**Addendum Number:** 02

**Owner:** Crawford County Highway Department

**Project Name:** New Shop & Office

**Project Number:** 0210855.00

A7.2

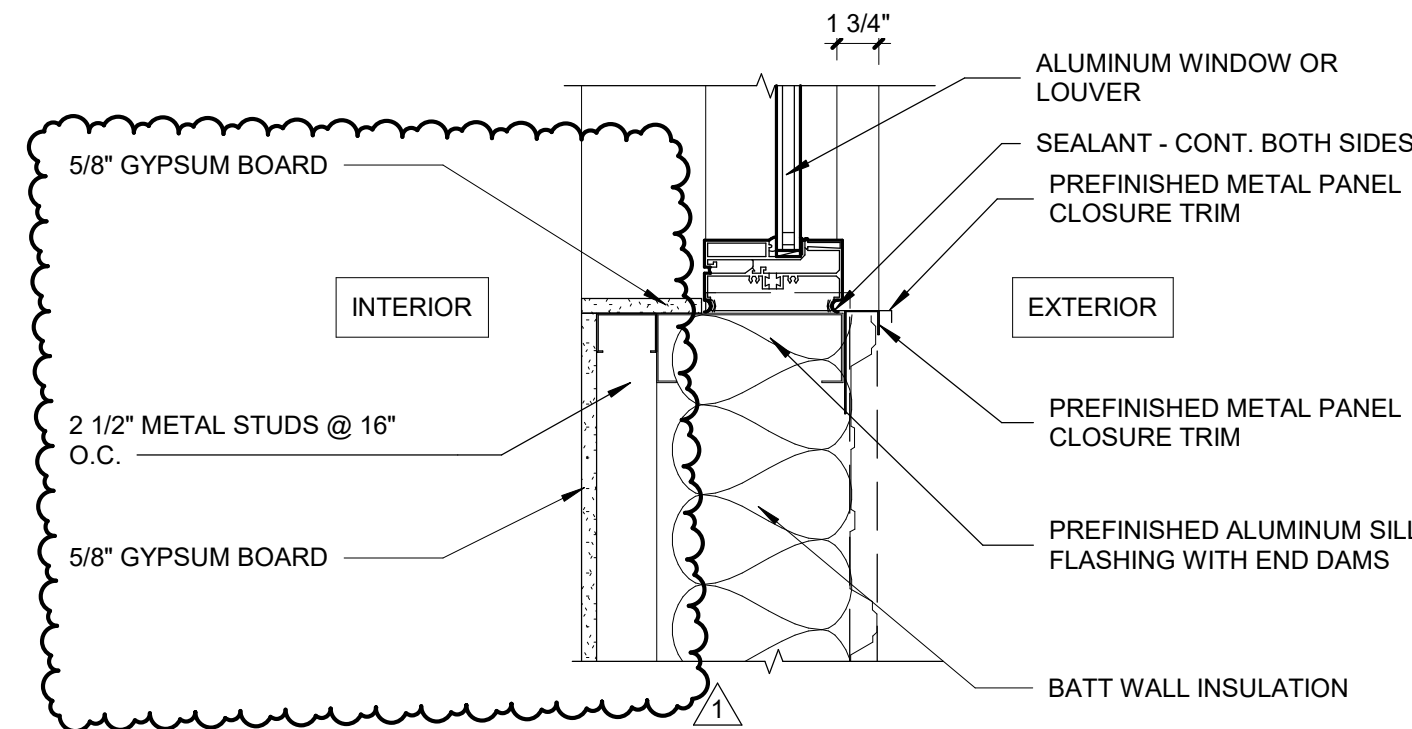
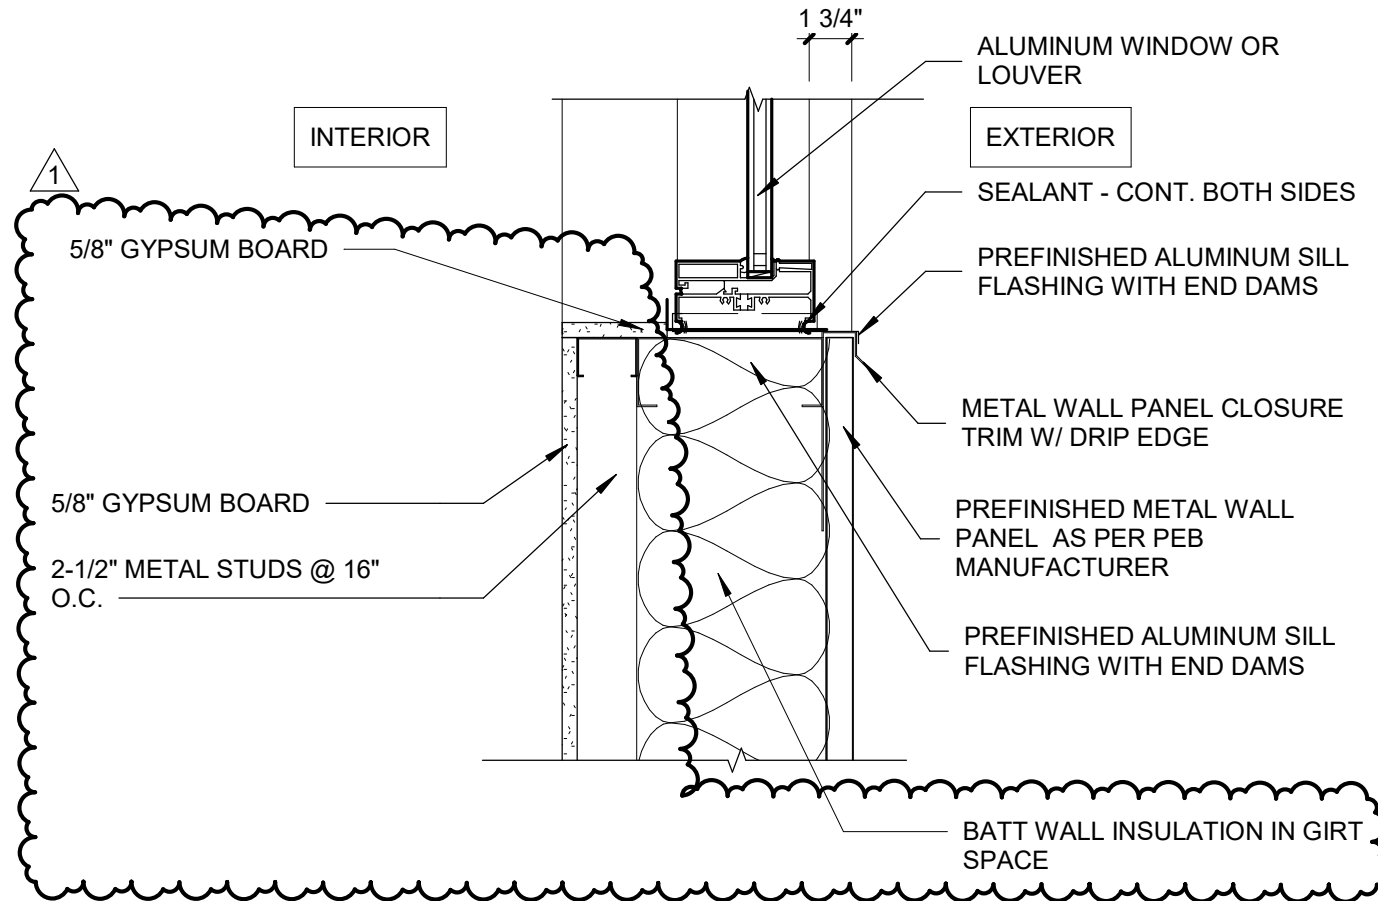
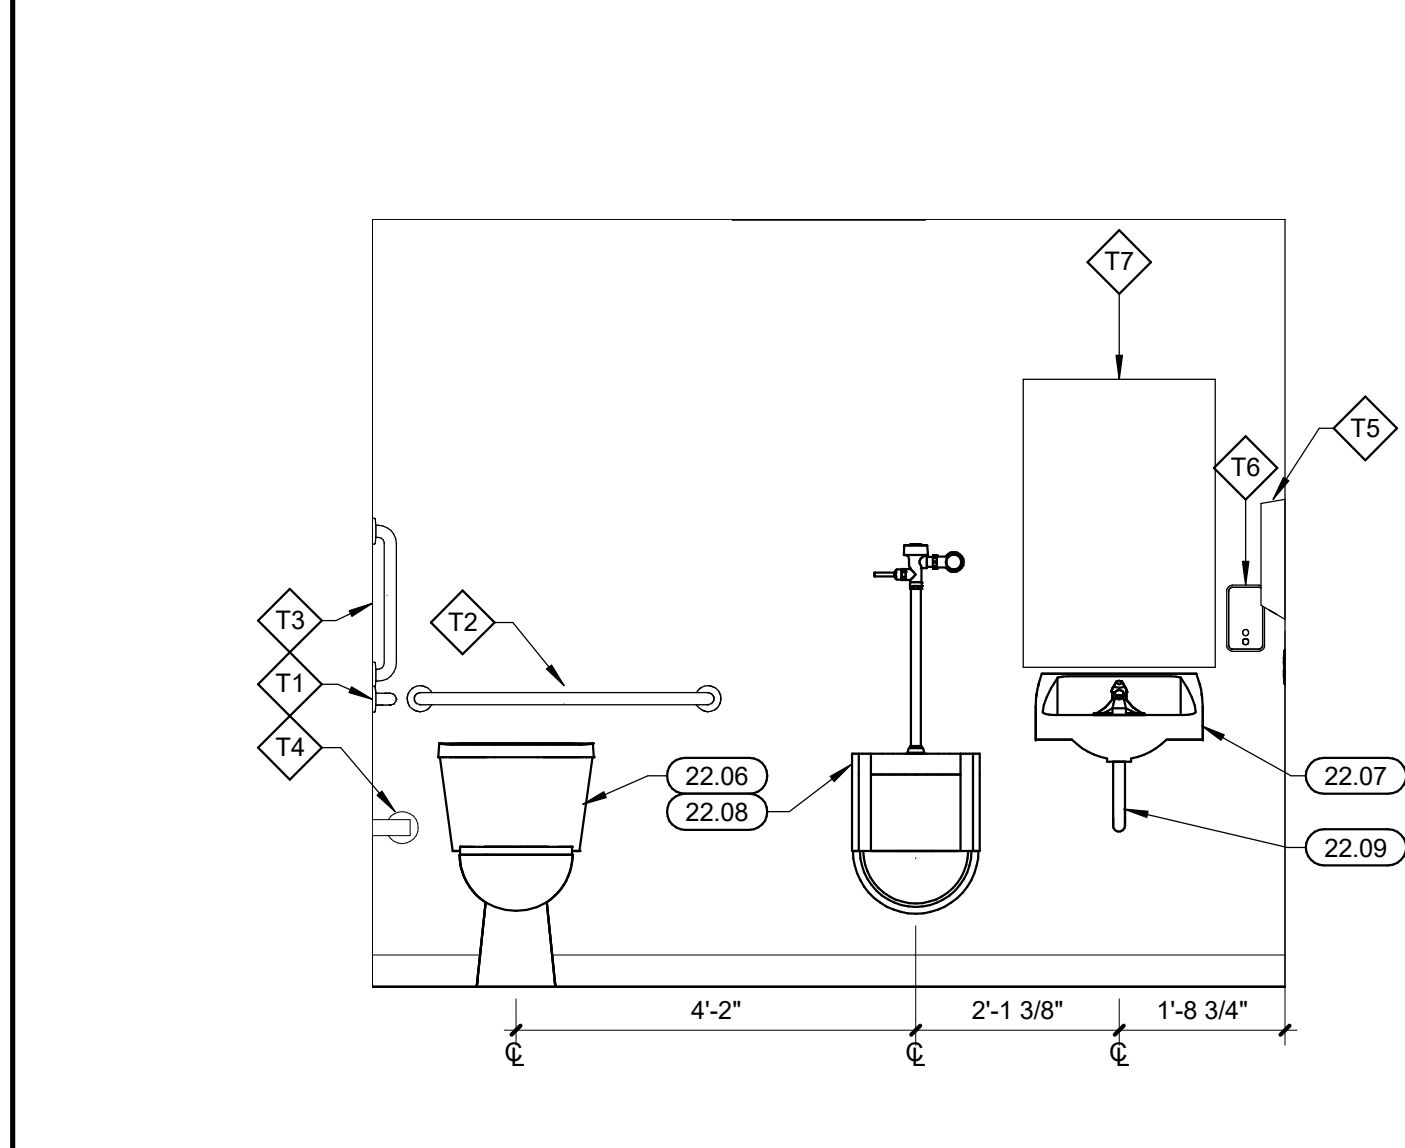
- d. Partition type P6 has been updated to show a liner panel on one side only. The liner panel shall be added to the side facing the Mechanic's Bay.
  - e. Partition type P1C has been added.
5. A7.2 – DOOR AND WINDOW DETAILS
- a. Details 1, 2, and 3 have been revised to show the 2 ½" metal studs and 5/8" gypsum board on the interior side of the girts.
6. A8.1 – INTERIOR ELEVATIONS AND ENLARGED PLANS
- a. The walls located around the columns shall be partition type P1C.
7. M6.1 – RADIANT FLOOR SCHEDULE
- a. The tube diameter and spacing may be changed based on delegated design by the radiant floor heating system manufacturer to provide a heating density of 22.3 BTH/SF as scheduled. Pumps P-3 and P-4 shall be sized to provide the required pressure differential and flow rate of the radiant floor design.
